AGENDA ITEM 4A

**PUD – Lots 5 and 6 Southport East (To Be Replatted
as Lots 1-3 Southport East Replat 15) —**

**CITY OF LA VISTA
PLANNING DIVISION
RECOMMENDATION REPORT**

RE: REV Development – PUD, CUP & Replat Applications – Initial Review Letter
Lots 5-6 Southport East

SHEET
C3.0

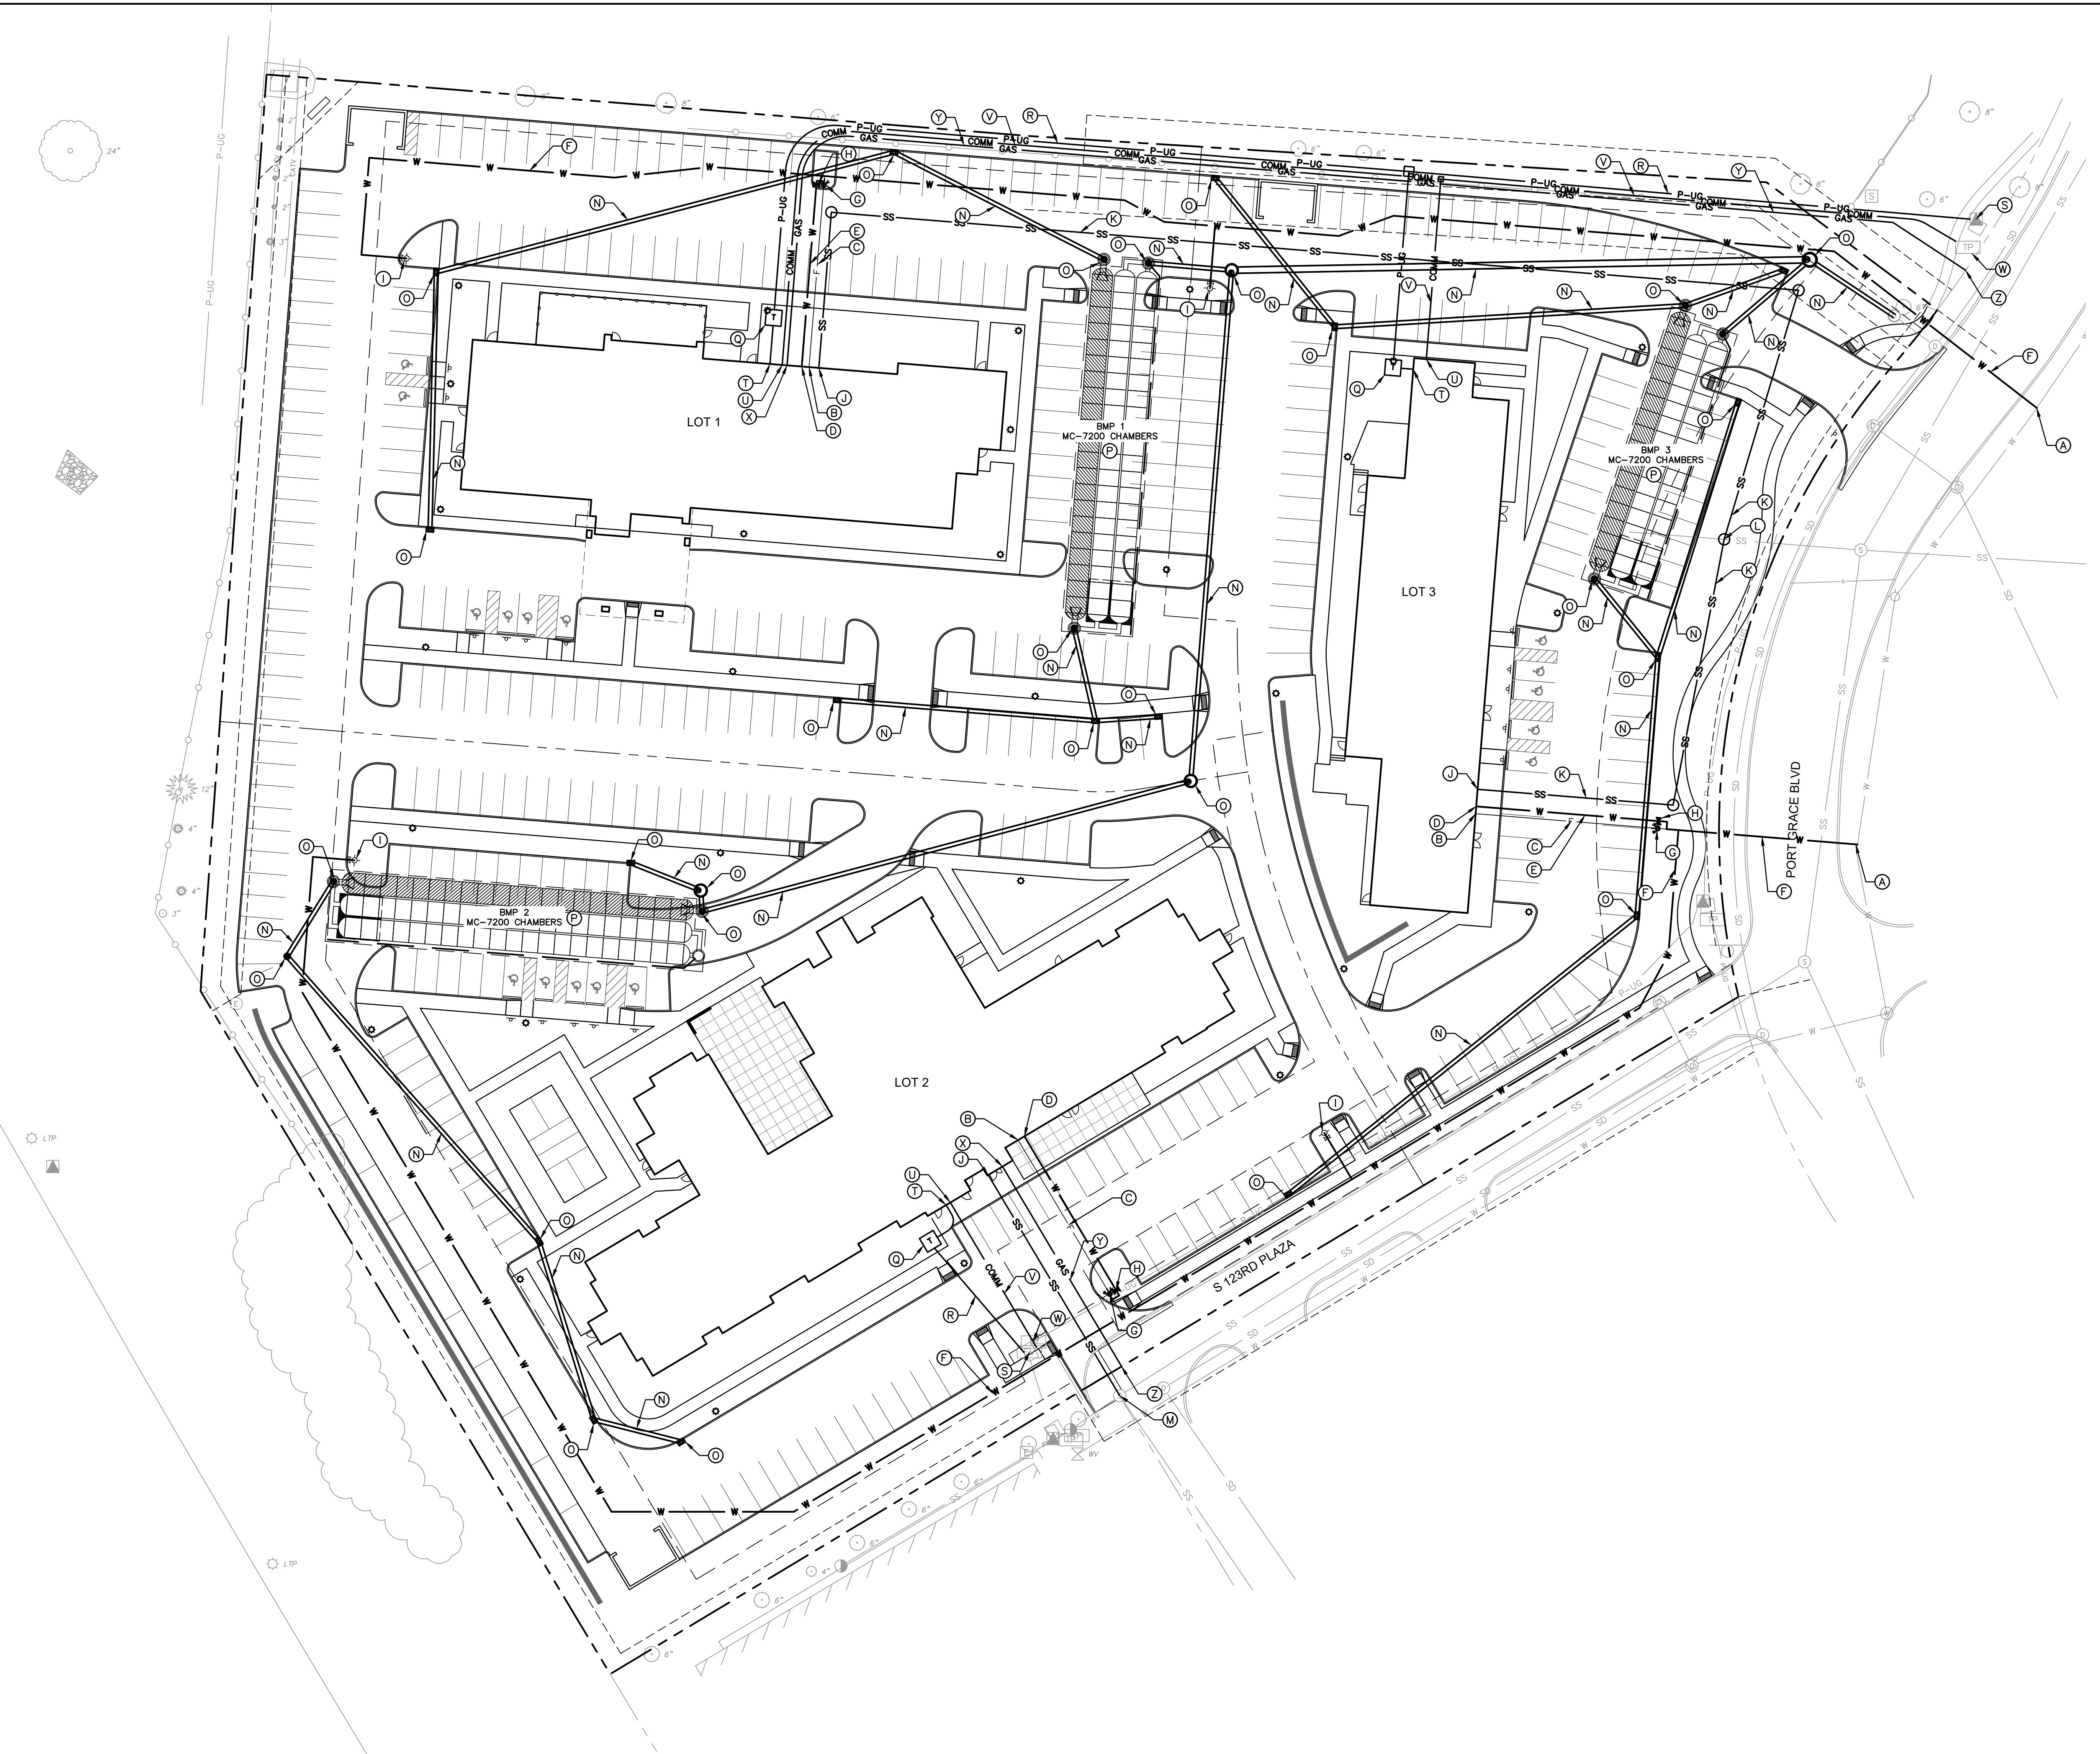
7. Replat Submittal Sheet 2.0 – Confirm parallel and typical parking stall configurations are consistent with Article 7 of the Zoning Ordinance.
8. Replat Submittal Sheet 2.0 – Sidewalk easements will be required along Port Grace Boulevard for portions of the public sidewalk.

Papillion Fire truck
Overall Length
Overall Width
Overall Body Height
Min Body Ground Clearance
Track Width
Lock-to-lock time
Max Wheel Angle

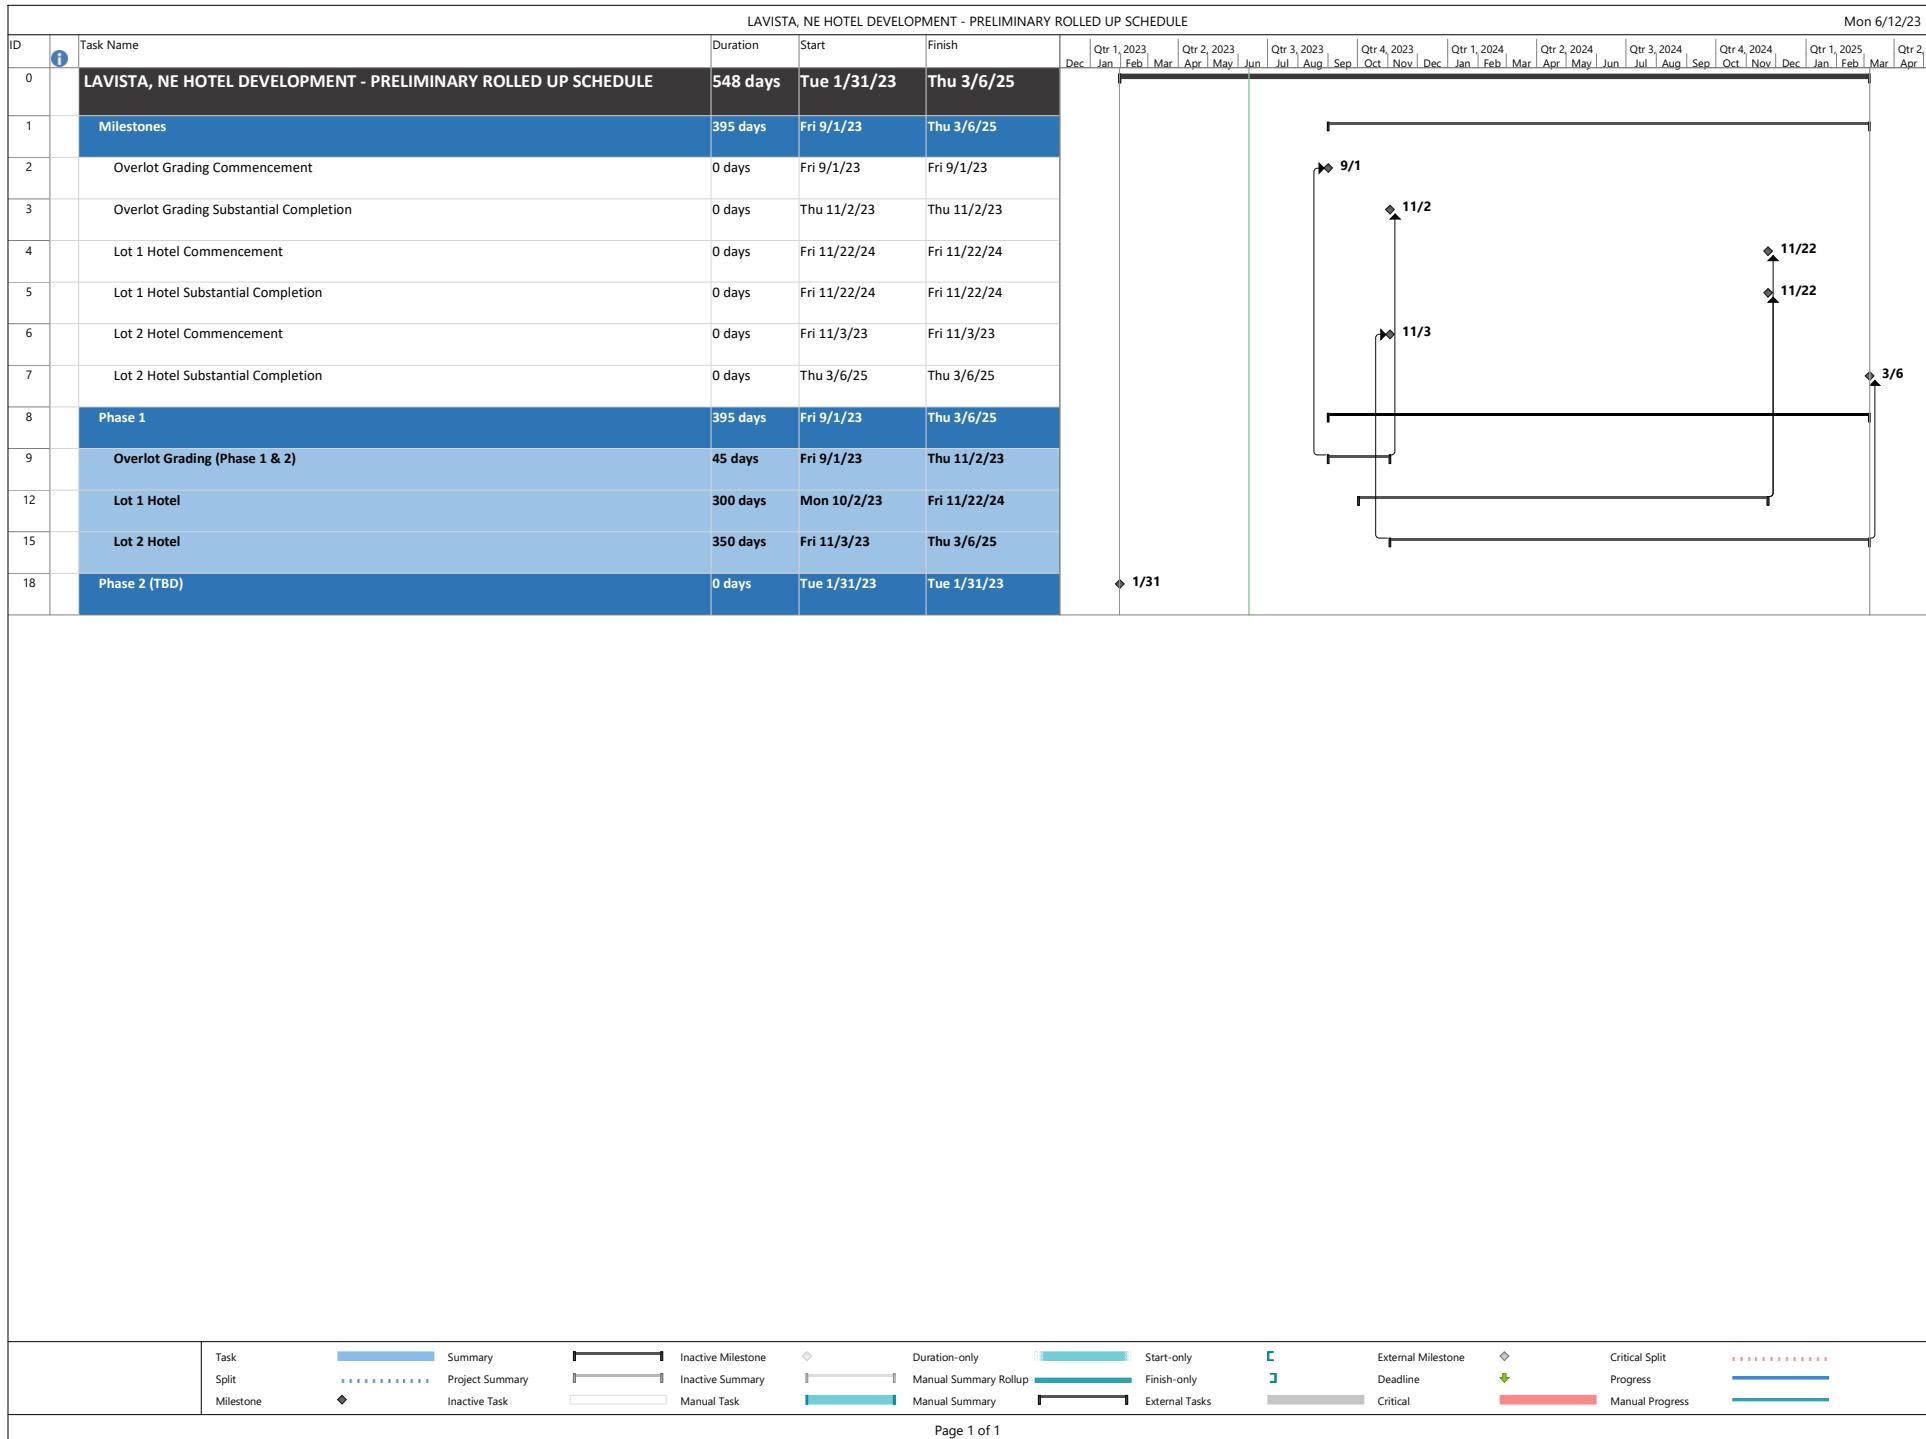
If they add an entrance at that point, in addition to the two existing ones, that would work too, right? The existing point on 123rd is the main logical traffic flow to Lot 1.

The code sections for the comment are NFPA 1 18.2.3.3 and IFC D106.3. The IFC appendix is not adopted in La Vista but gives guidance on measuring the distance between access points. If the access point moves to the west on 123rd to the corner, they meet the separation that would be acceptable.

Correct, they would lose the parking spaces, that is all.
